Number: E-04-003

ENGINEERING DIRECTIVE

DETECTABLE WARNING PANELS

Effective immediately, the *1996 Metric Edition Construction and Traffic Standard Details* and the *1977 [English Edition] Construction Standards* are amended with the following new drawings (attached):

M/E 107.2.1 Wheelchair Ramp on Narrow Sidewalk

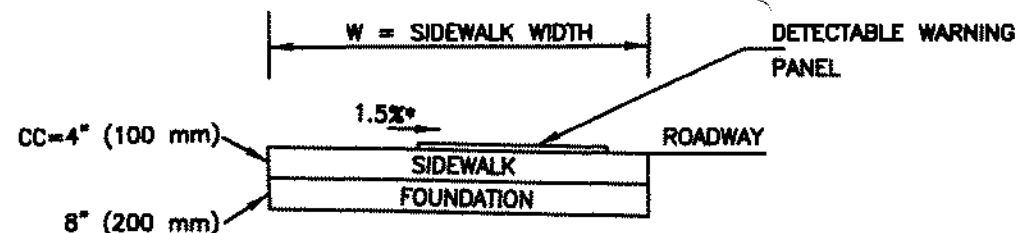
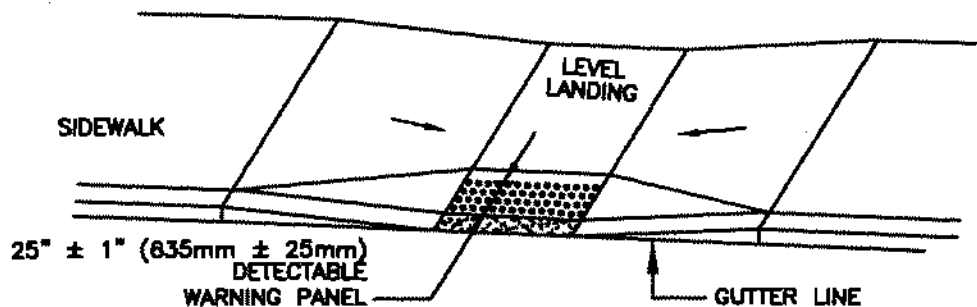
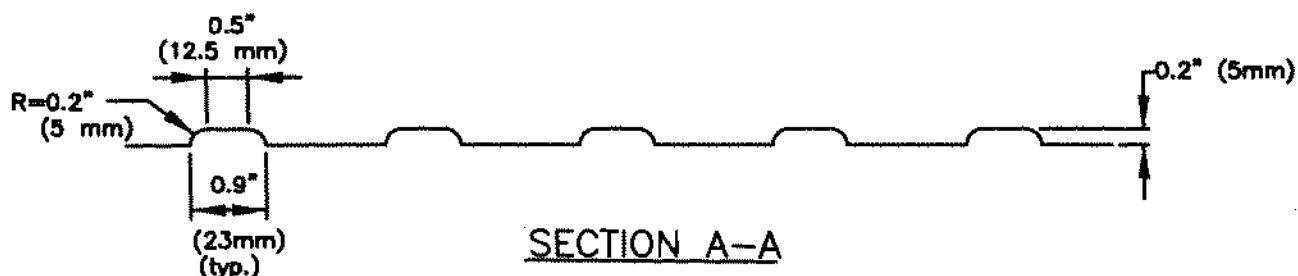
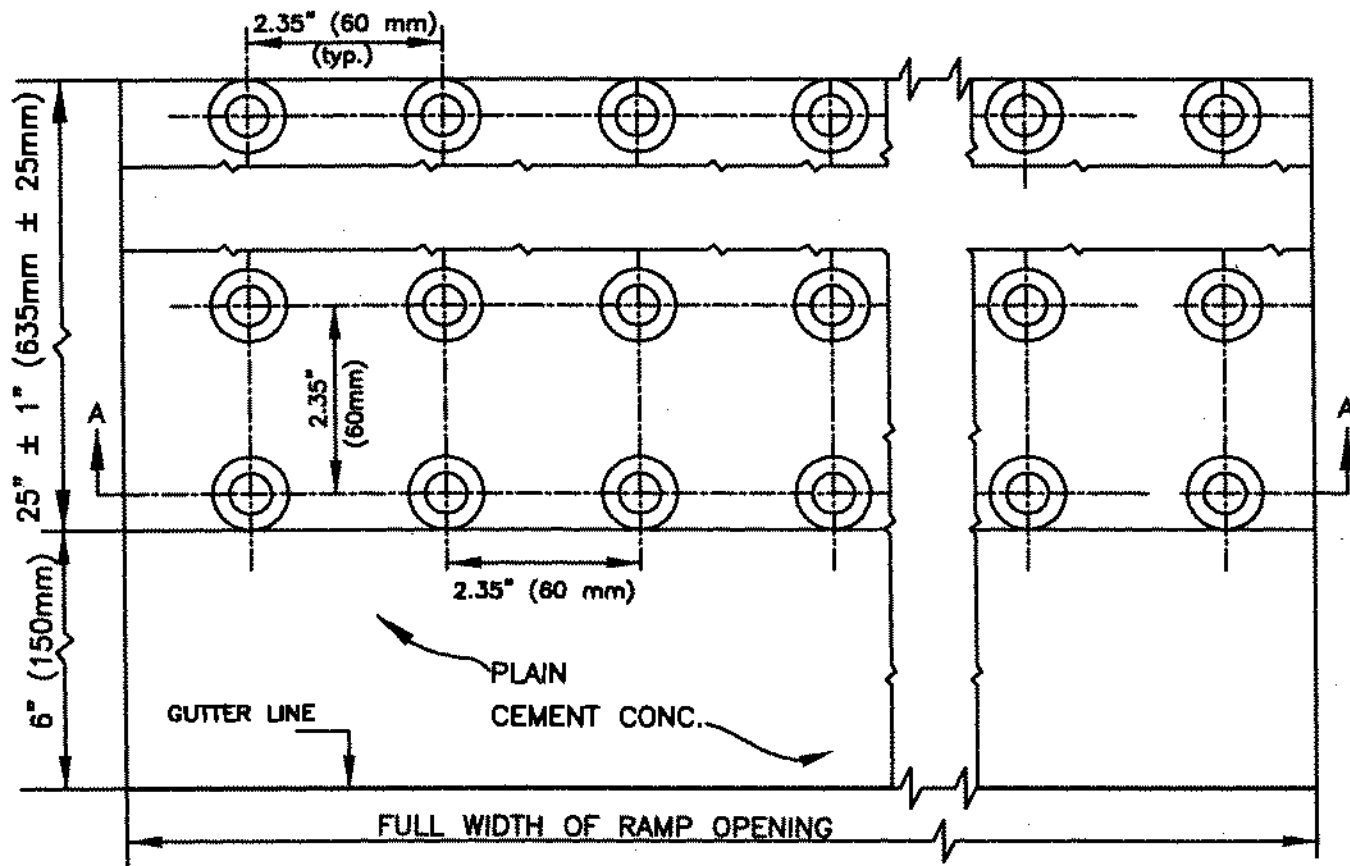
These drawings have been issued to comply with the FHWA enforcement of the Federal Access Board's decision to require detectable warning panels at certain locations. Detectable warning panels are intended to alert sight-impaired pedestrians that they are about to enter potentially hazardous locations. The drawings also include a new configuration of wheelchair ramps that can be used for narrow sidewalks.

Detectable warning panels shall be installed on all wheelchair ramps as shown on the drawings. Panels shall also be installed on all sidewalks that are crossed by train tracks to warn pedestrians that they are about to enter a track area. These panels shall be 25" (635 mm) long in the direction of travel and shall be installed across the entire sidewalk. The designer shall show the proposed location(s) of warning panels on the plans after consulting with the operator of the tracks about the safe envelope required around the tracks. The Resident Engineer shall verify the actual location(s) of warning panels with the operator of the tracks prior to installation.

Designers shall include detectable warning panels in all applicable design documents immediately.

For projects already under construction or for which detectable warning panels are not otherwise included in the design documents at the time of construction, contractors shall install all required detectable warning panels in all locations where the applicable wheelchair ramps or sidewalk surfaces are not already completed, effective immediately.
